RAIL COACH FACTORY, KAPURTHALA

CAI N O.: ED/CAI/026 Dated: 27.12.2023

COACH ALTERATION INSTRUCTION SHEET FOR MODIFICATIONS IN EXISTING LHB NON AC SCN TYPE COACHES

This Coach Alteration Instruction Sheet has been issued for modification in existing **LHB Non AC SCN type coaches** wherein following steps are to be taken for modifications in the coach:

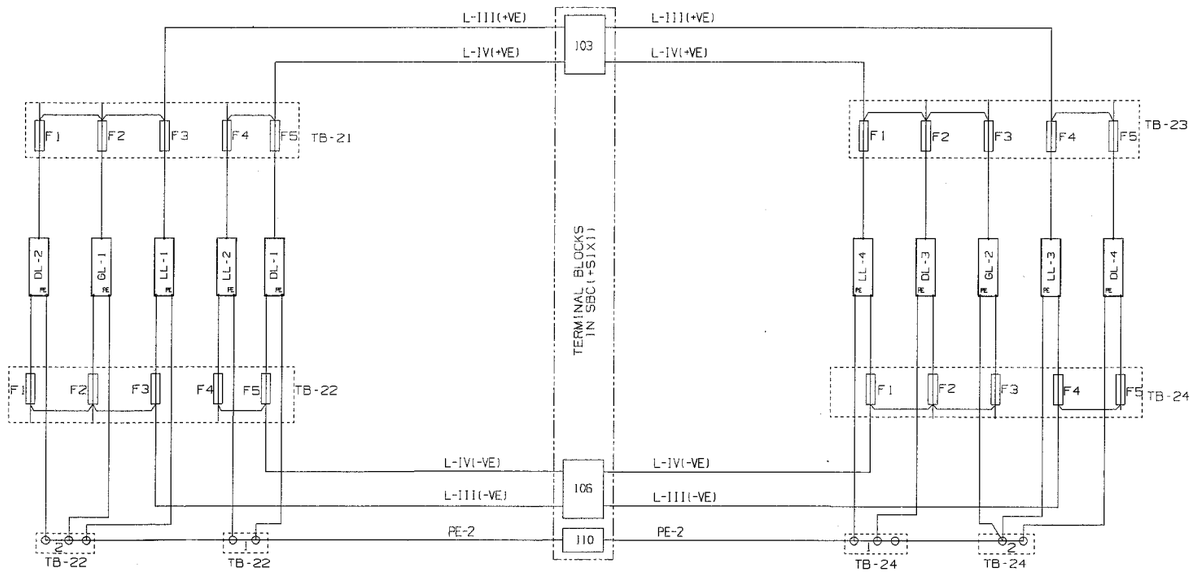
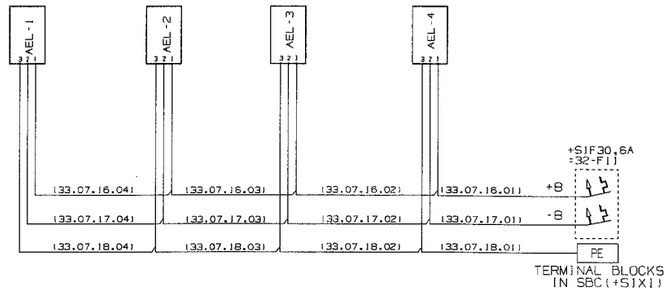
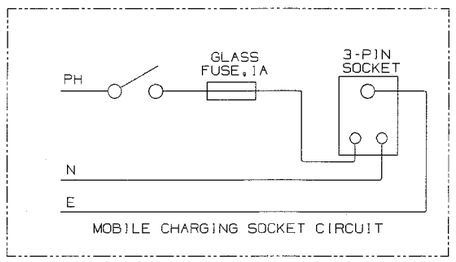
iii. Connect all the LIGHTS, FANS, NIGHT LIGHT circuits alongwith **Earthing** on the Cage clamp terminals with glass fuses in ref. to drawing no. **SKED 922** properly.

ii. However as per revised scheme to drawing SKED922, 04 nos. mobile charging sockets are to be provided in cabin side & corridor side wall side (i.e. 3nos. on Cabin side & 01 no. mobile charging socket provided in Corridor side side walls).

v. Connections of Mobile Charging sockets points in Switch Plate assemblies shall be made in ref. to drawing no. **SKED 922.**

ii. Connect the Male-Female WAGO type connectors supplied by the vendor alongwith fan supply. Connect the all the BLDC FAN circuits on the Cage clamp terminals with glass fuses in ref. to drawing no. **SKED 922** properly.

ii. Connections for Light, Fan and Mobile charging points shall be made properly as per ref. drawing no. **SKED 922.** No looseness of wires in switch plates shall be there and same shall be ensured during fitment.

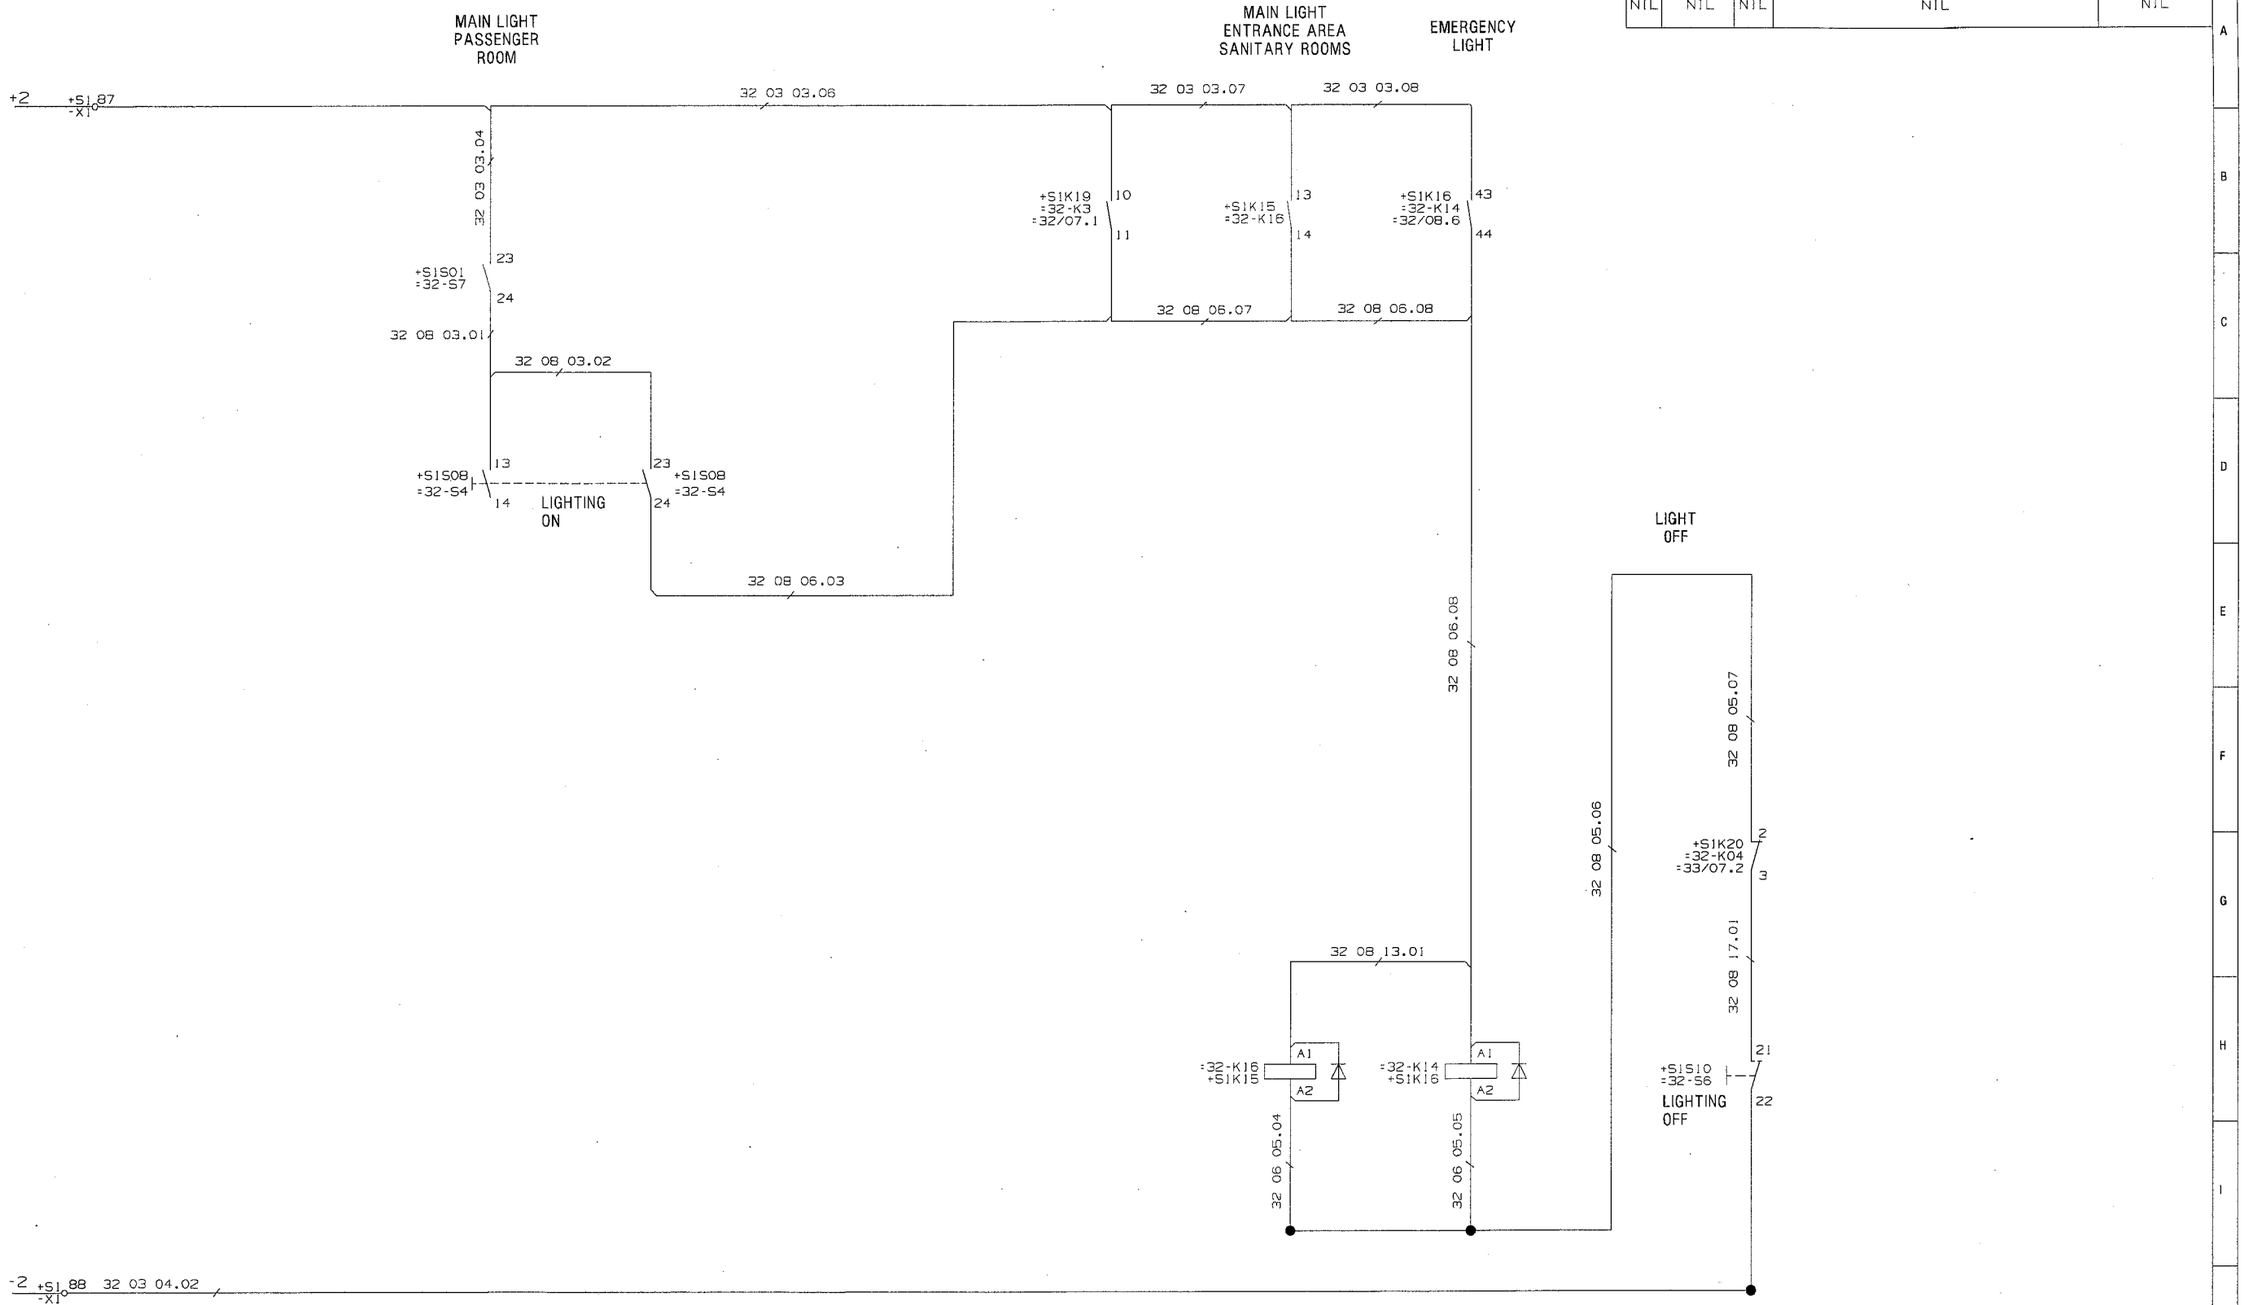
Changes in the Switchboard Cabinet to Spec no EDTS333		
A	**Modifications in the Schematic drawing of the SBC :**	
A.1	**Drawing no LS70202 sheet 1/13 revised to drawing no SKED 925**	
	1	Specification for the cables revised to RDSO specification no ELRS/SPEC/0019 Rev-4
A.2	**Drawing no LS70202 sheet 2/13 revised to drawing no SKED 926**	
	1	Temperature sensor wires for the Regulated Battery Charger deleted
A.3	**Drawing no LS70202 sheet 3/13**	
	1	No change
A.4	**Drawing no LS70202 sheet 4/13 revised to drawing no SKED 927**	
	1	Transformer 33T01/+S1F74, 1 kVA 230/110 volts deleted
	2	Auxiliary contactor lighting 33K09/+S1K48, item 89 of the BOM
	3	MCB 33F22/S1F39, 33F23/S1F40, 33 F24/S1F41 deleted
	4	Insulation Monitoring Relay 93A1/S1A06 deleted
	5	Wago type Fuse 33F35/S1F74 and 33F36/S1F75 marked spare
A.5	**Drawing no LS70202 sheet 5/13 revised to drawing no SKED 928**	
	1	Auxiliary contactor lighting 32K10/+S1K11, item 59 of the BOM

2	Contactor Lighting with Diode 32 K12/+S1K14 item 60 of the BOM
	3	Contactor Lighting with Diode 32 K13/+S1K13 item 61 of the BOM
	4	Time Delay Relay 32 K15/+S1K17 item 63 of the BOM
	5	Circuit modified accordingly for all lighting on DC
A.6	**Drawing no LS70202 sheet 6/13 revised to drawing no SKED 929**	
	1	MCB 32F06/+S1F25, MCB 10 A DP, nomenclature changed to Lighting
	2	MCB 32F07/+S1F26, MCB 10 A DP, nomenclature changed to Lighting
	3	MCB 32F15/+S1F34, MCB 10 A DP, nomenclature changed to spare
A.7	**Drawing no LS70202 sheet 7/13**	
	1	No change
A.8	**Drawing no LS70202 sheet 8/13 revised to drawing no SKED 930**	
	1	AC contactors eliminated and lighting circuit modified to dc circuit only
A.9	**Drawing no LS70202 sheet 9/13**	
	1	No change

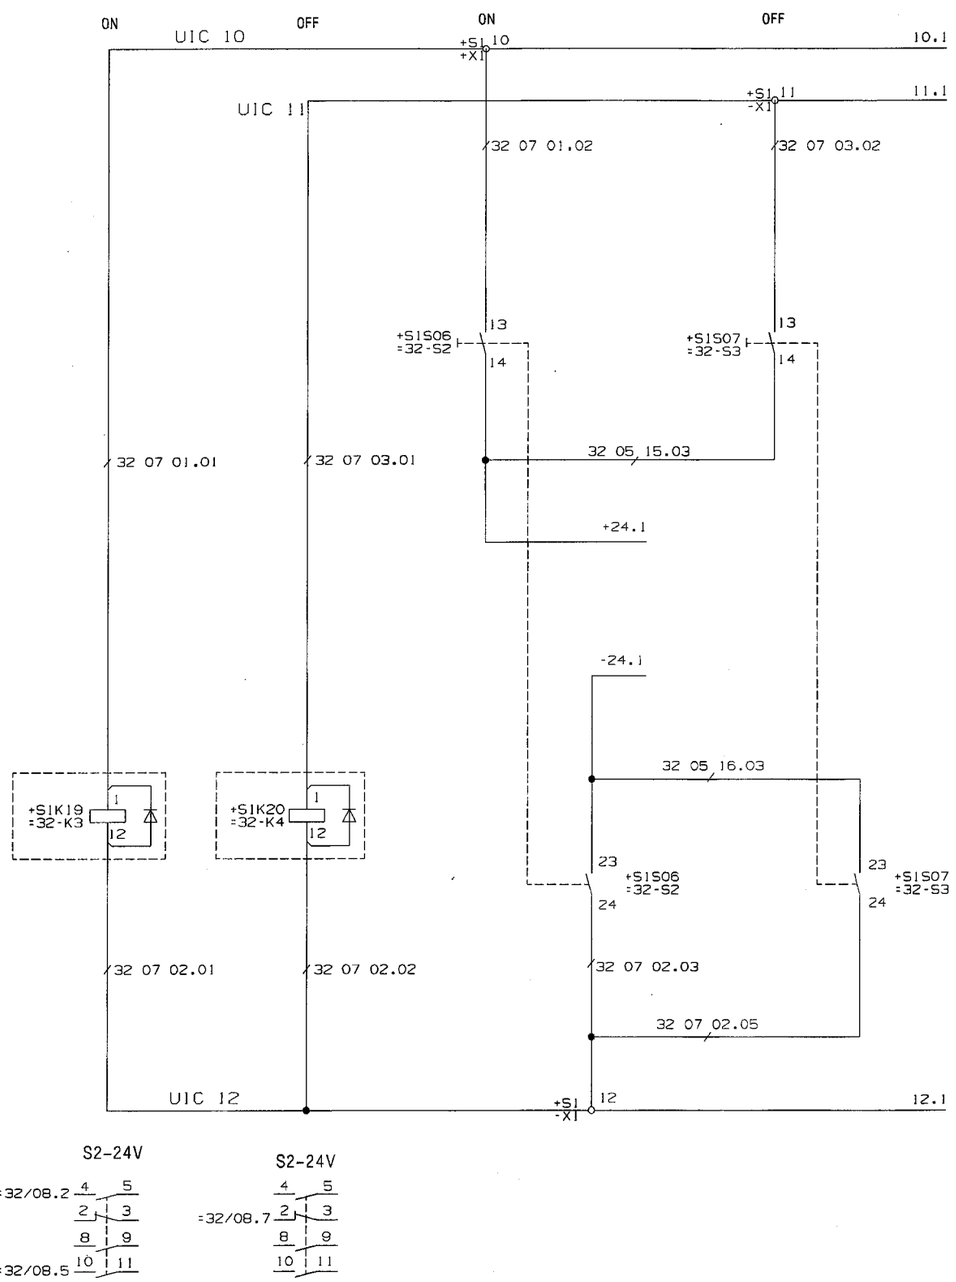
A.10	**Drawing no LS70202 sheet 10/13**	
	1	No change
A.12	**Drawing no LS70202 sheet 11/13 revised to drawing no SKED 931**	
	1	Minimal Voltage Relay MR9, 110 V 32U13/+S1K17 item 69 of the BOM deleted
A.13	**Drawing no LS70202 sheet 12/13**	
	1	No change
A.14	**Drawing no LS70202 sheet 13/13 revised to drawing no SKED 932**	
	1	MCB connected to DC in place of AC
	2	MCB 32F22/S1F38, 32F23/S1F39, 32F24/S1F40 Added of 6 Amps, 250 V DC
	3	MCB 32F25/S1F41, 32F26/S1F42 Added of 6 Amps, 250 V DC
	4	MCB 33F109/S1F109 Added of 6 Amps, 250 V AC
	5	RCBO 4-pole 16 amps, 30mA added for mobile charging circuit
	6	MCB +S1F30, 6AMP = 32-F11 to be used for connection of the AEL circuit
	7	MCB +S1F42, 6AMP = 32-F26 to be used for connection of the Reservation Chart Light
Note		
	1	**HOG modification as per RDSO Modification sheet no RDSO/PE/MS/AC/0051-2017 Rev-2, Amdt-1 (or Latest Edition) issued vide RDSO letter no EL/1.6.9.22 Dated 28/07/2014, 24/09/2015, 21/03/2017 may be incorporated (copy enclosed)**

SCALE	SSE/ED	
	CHD	
	DRN	
REF.DRG.No.	CC72069, ALT-d	
PL NO.	NIL	
DRG.NO.	SKED-933	
ALT. NIL	SIZE A2	SHEET 1/1

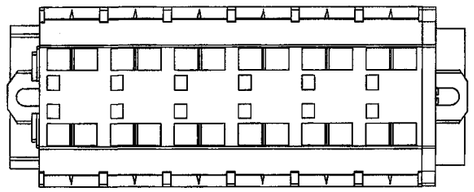
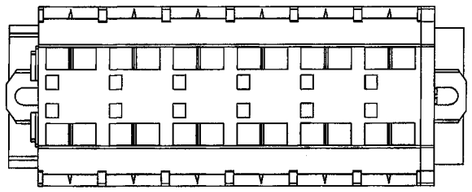
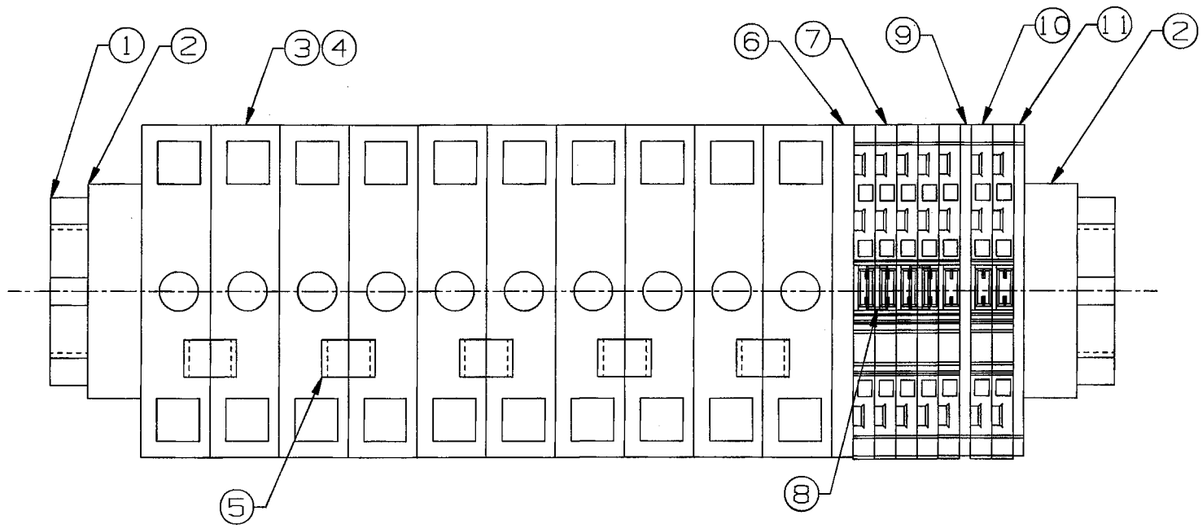
i. Cage clamp terminals with glass fuses as per drawing **SKED 933** shall be mounted on the existing bracket in each cabin on both side of the cabin area with the aid of suitable hardwares .

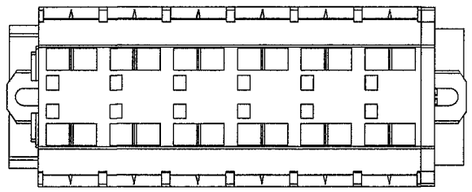
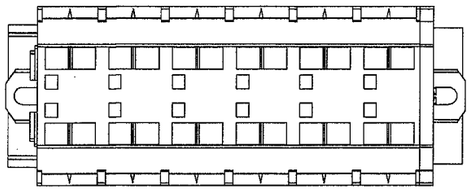
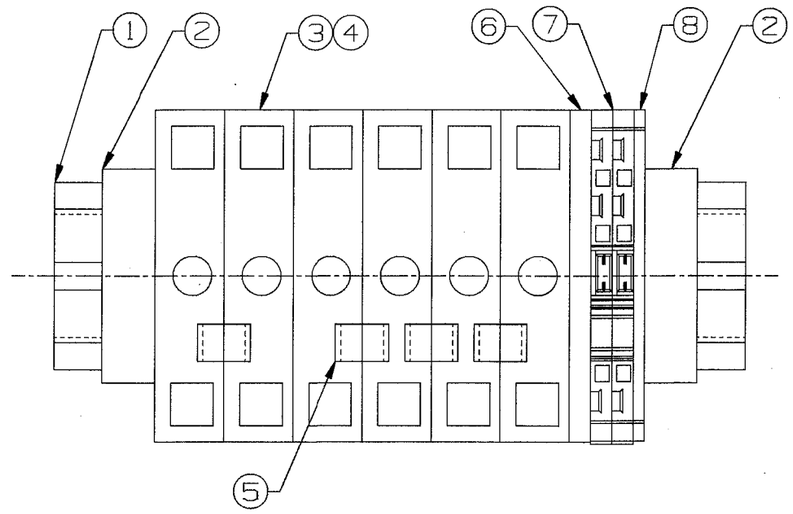
ii. Cage clamp terminals with glass fuses as per drawing **SKED 934** shall be mounted on the existing brackets in each doorway area on both side with the aid of suitable hardwares

SCALE	SSE/ED	
	CHD	
	DRN	
REF.DRG.NO.	NIL	
PL NO.	NIL	
DRG.NO.	SKED-935	
ALT. NIL	SIZE A3	SHEET 1/2

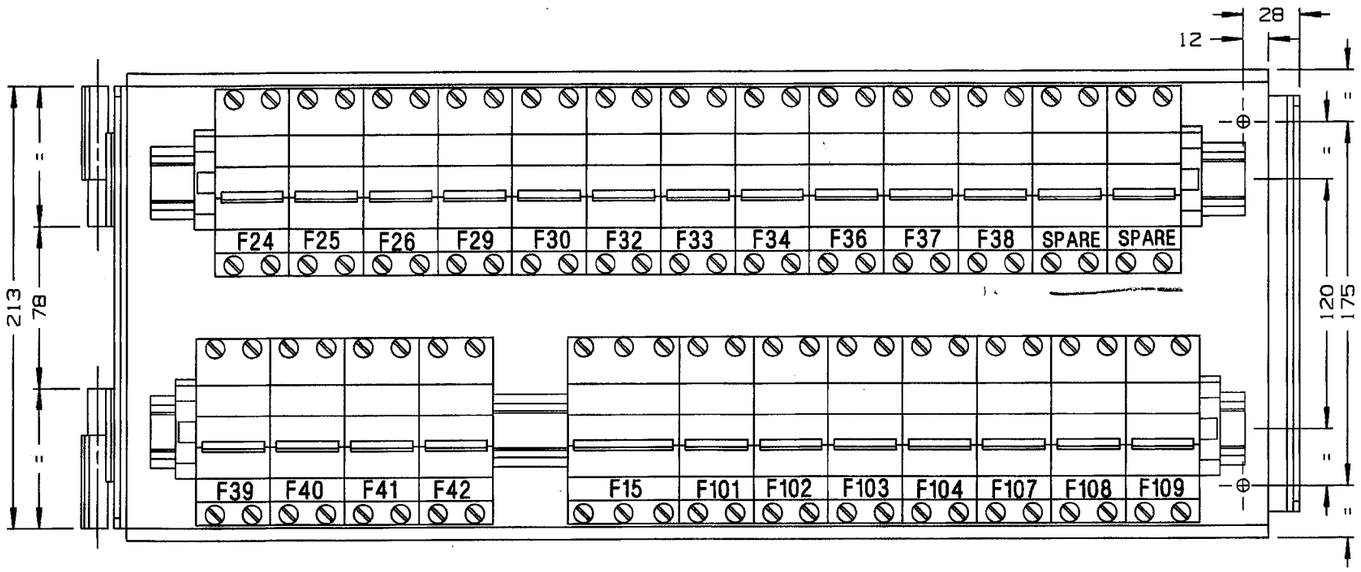
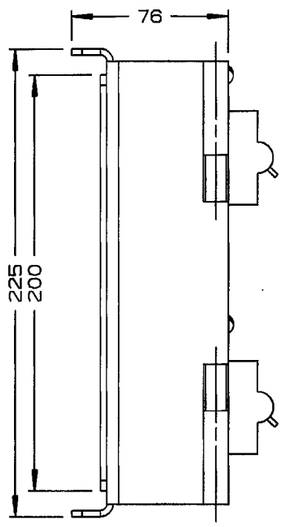
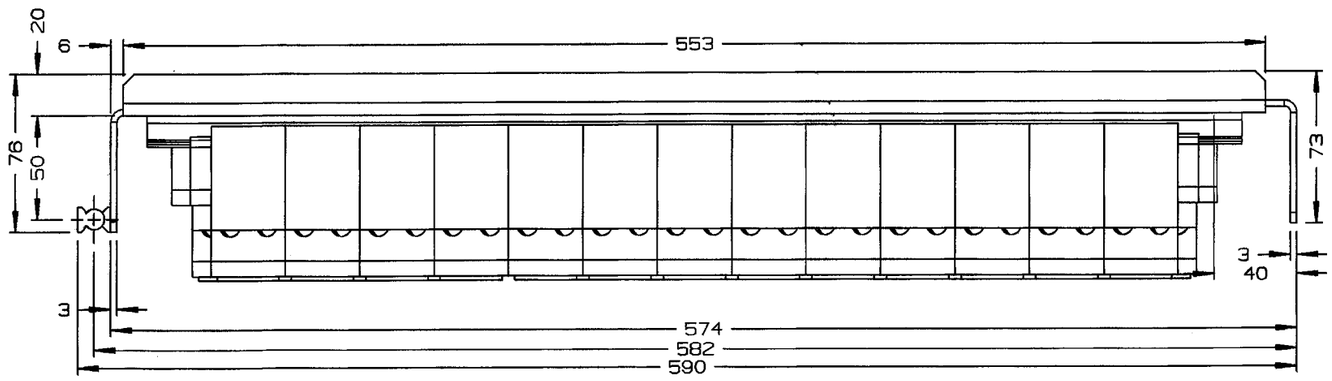
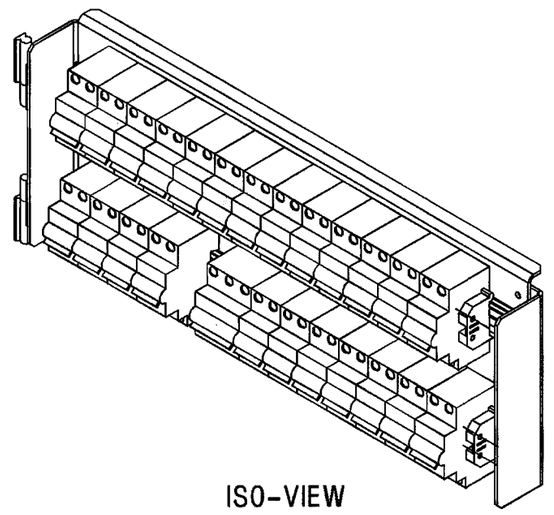
2.1	SKED 935 (SHEET 1 OF 2)	MCB Holder for Switch Board Cabinet
2.2	SKED 935 (SHEET 2 OF 2)	Equipment back mounting plate for Switch Board Cabinet .
4.	RDSO/PE/SPEC/TL/0158-2010 (REV.-0), Table-1	RDSO Specification for 9kVA Transformer 750V/415V/190V 3-Phase Distribution Transformer
